City of Portland, Maine – Building or Use Permit Application 389 Congress Street, 04101, Tel: (207) 874-8703, FAX: 874-8716

Location of Construction: 52 Merrill St		Owner: Phyllis J. Latini		Phone: 892-0133		Permit No: 950067	
Owner Address: 75 Burke Rd - Standish, ME		Leasee/Buyer's Name:		Phone:		Business Name:	
Contractor Name: 3222		Address:		Phone:		<div style="border: 2px solid black; padding: 5px; text-align: center;"> PERMIT ISSUED Permit Issued: FEB - 1 1995 CITY OF PORTLAND </div>	
Past Use: vacant lot		Proposed Use: 1-fam dwlg w garage		COST OF WORK: \$ 74,000 FIRE DEPT. <input type="checkbox"/> Approved <input type="checkbox"/> Denied			
Proposed Project Description: construct 1-fam dwlg w garage		PEDESTRIAN ACTIVITIES DISTRICT (P.U.D.) Action: Approved <input type="checkbox"/> Approved with Conditions <input type="checkbox"/> Denied <input type="checkbox"/>		Signature:		Signature:	
Permit Taken By: C. Chase		Date Applied For: 1/11/95		Signature:		Date:

RE: Certificate of Occupancy
52 Verrill Street (lot 18)

Amended Plan for (Lot 18) Verrill Street - Portland

40.03
Lot 18

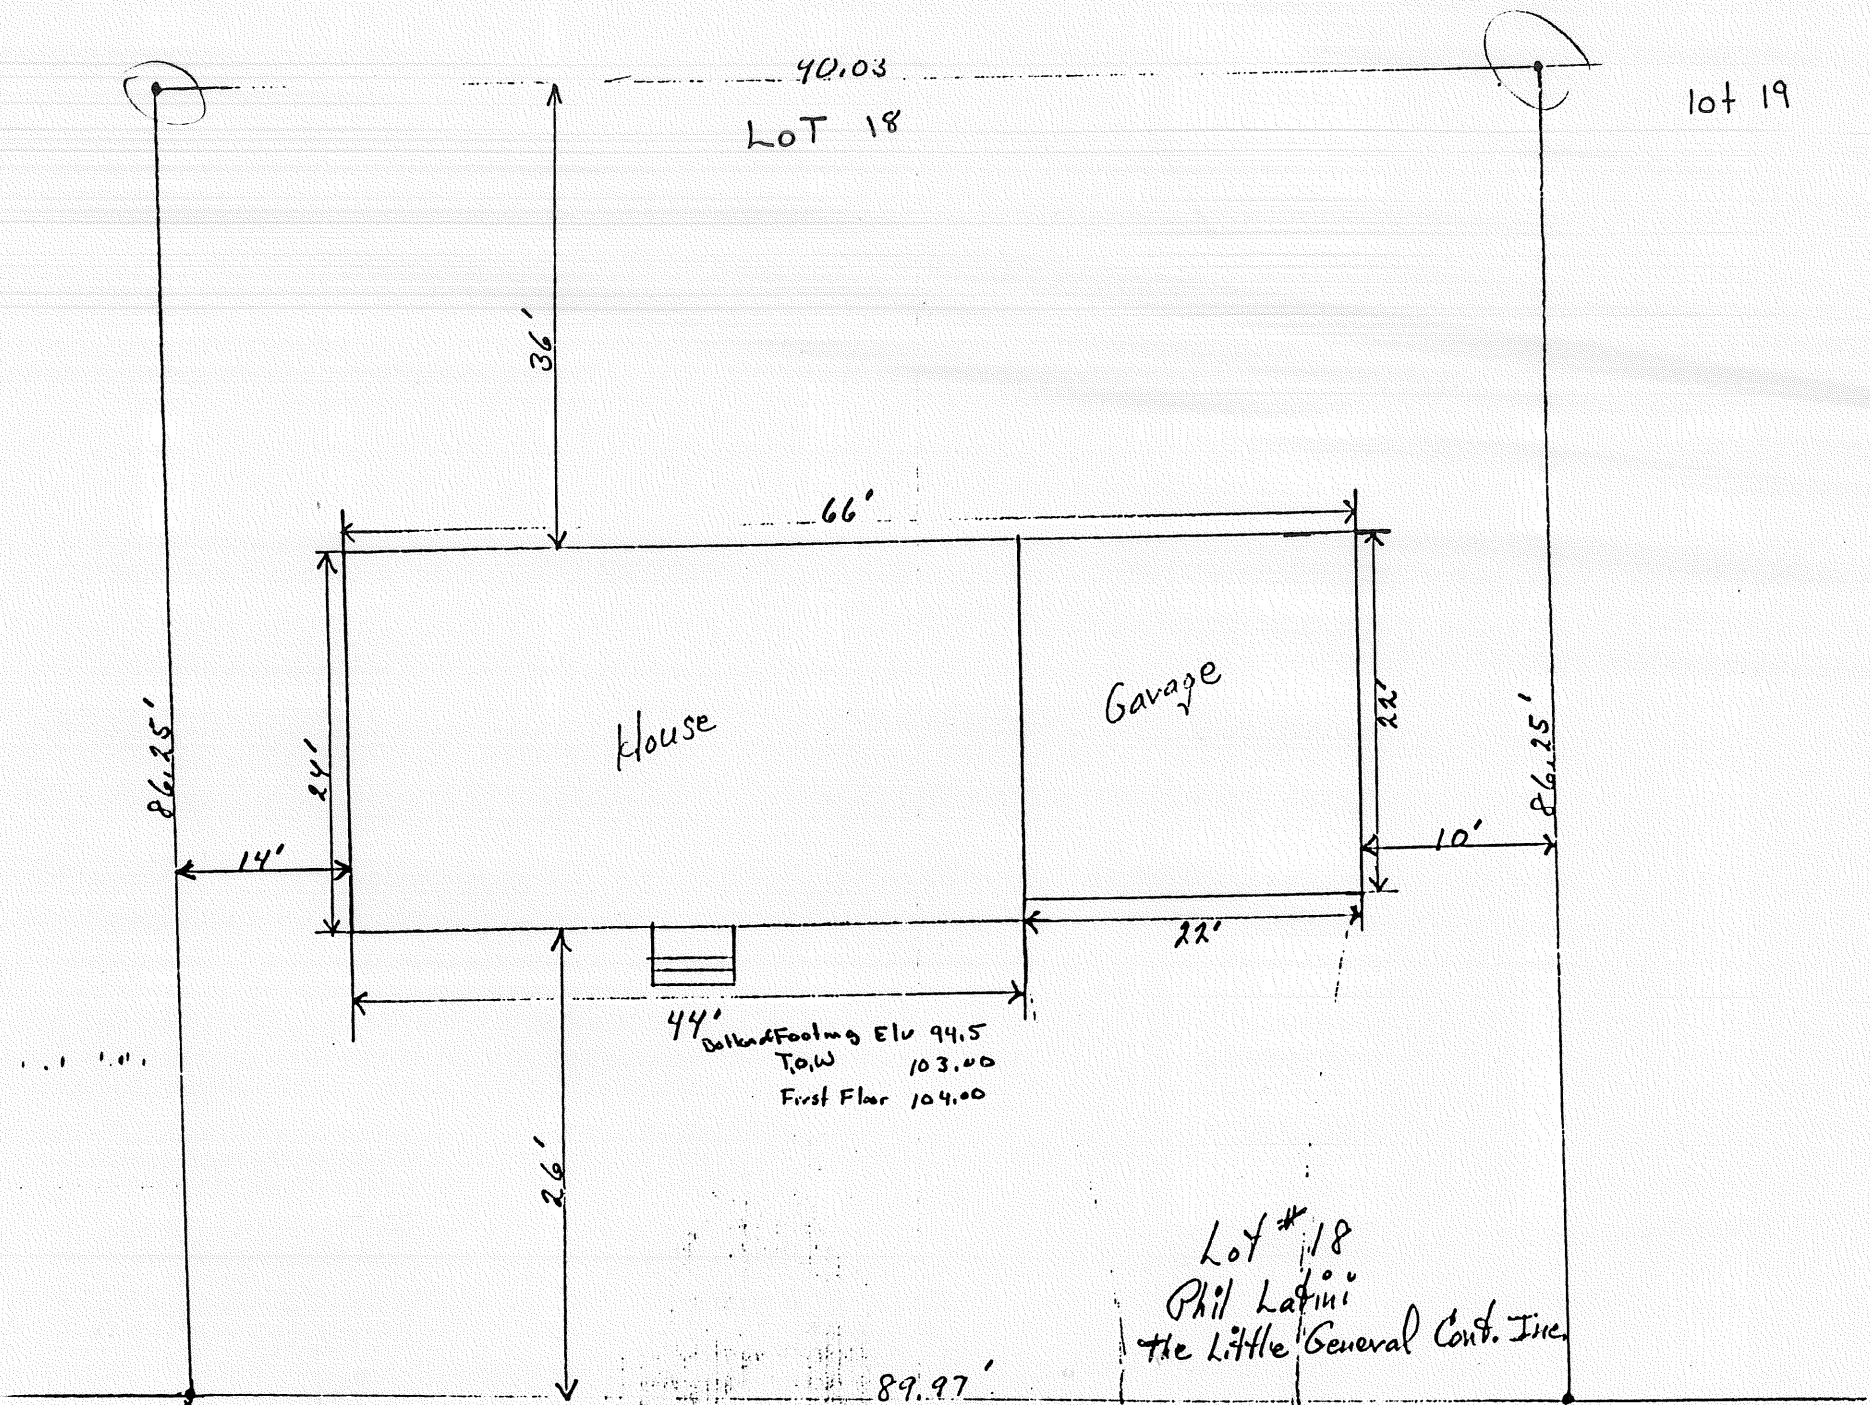
Rear Yards - 36' shown - 25' req.

→ Side Yards - 14' & 10' shown

20' required ^{N/A} on side St and 8' on ~~both~~ ^{both}

Front Yards - 26' shown - 25' req.

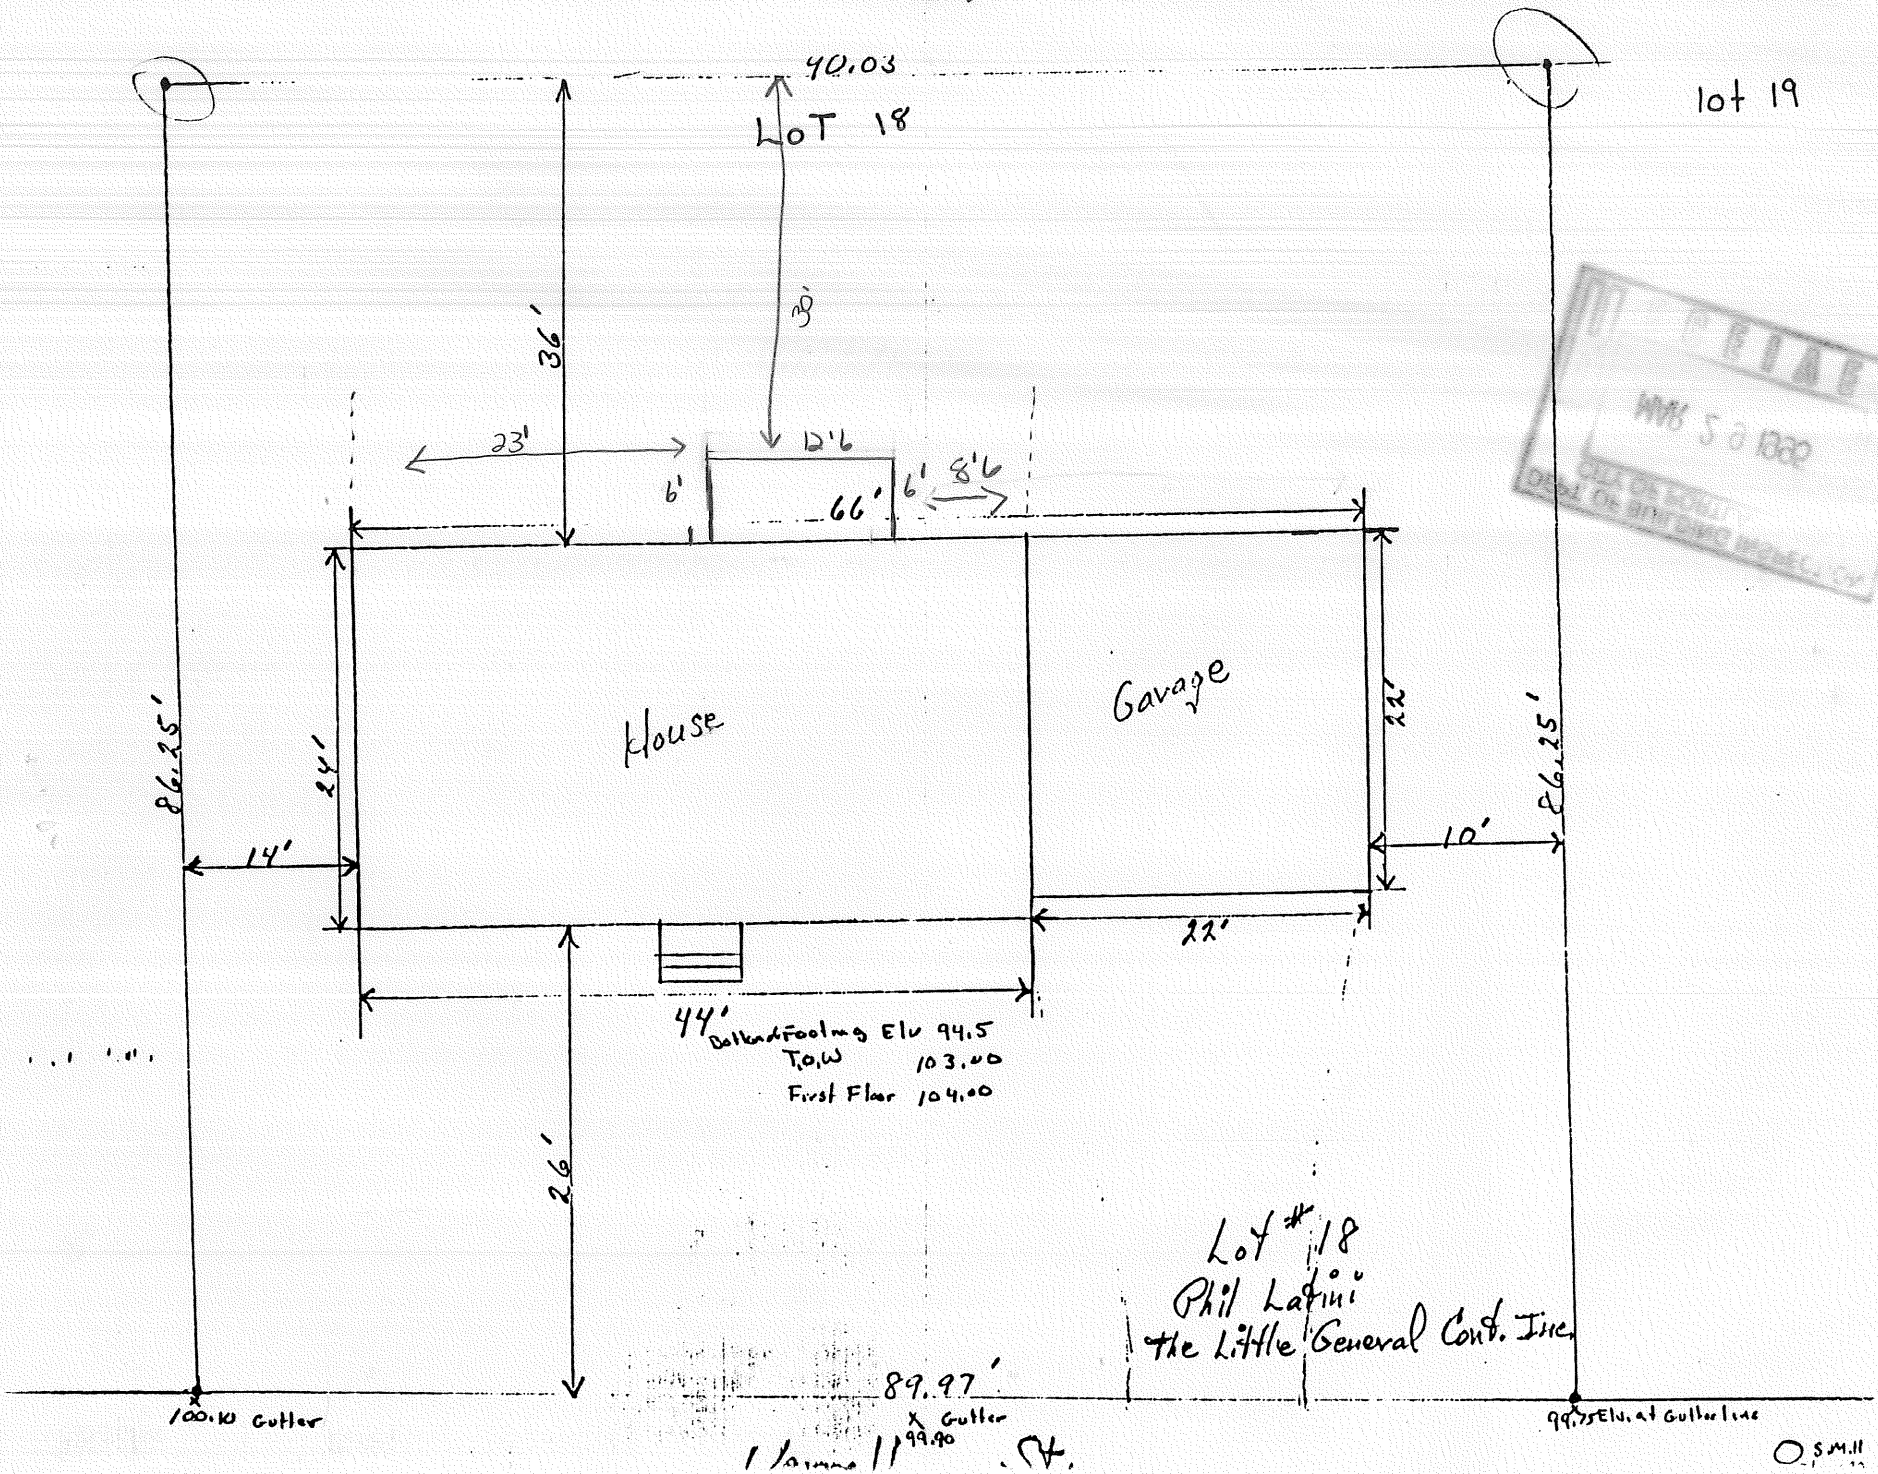
Your applications to construct deck has been reviewed and a permit is herewith issued subject to the following requirements: This permit does not excuse the applicant from meeting applicable State and Federal laws.

1. A 25 foot rear yard setback is required.
2. Guardrail & Handrails-A guardrail system is a system of building components located near the open sides of elevated walking surfaces for the purpose of minimizing the possibility of an accidental fall from the walking surface to the lower level. Minimum height all Use Groups 42", except Use Group R which is 36". In occupancies in Use Group A, B, H-4, I-1, I-2 M and R and public garages and open parking structures, open guards shall have balusters or be of solid material such that a sphere with a diameter of 4" cannot pass through any opening. Guards shall not have an ornamental pattern that would provide a ladder effect.
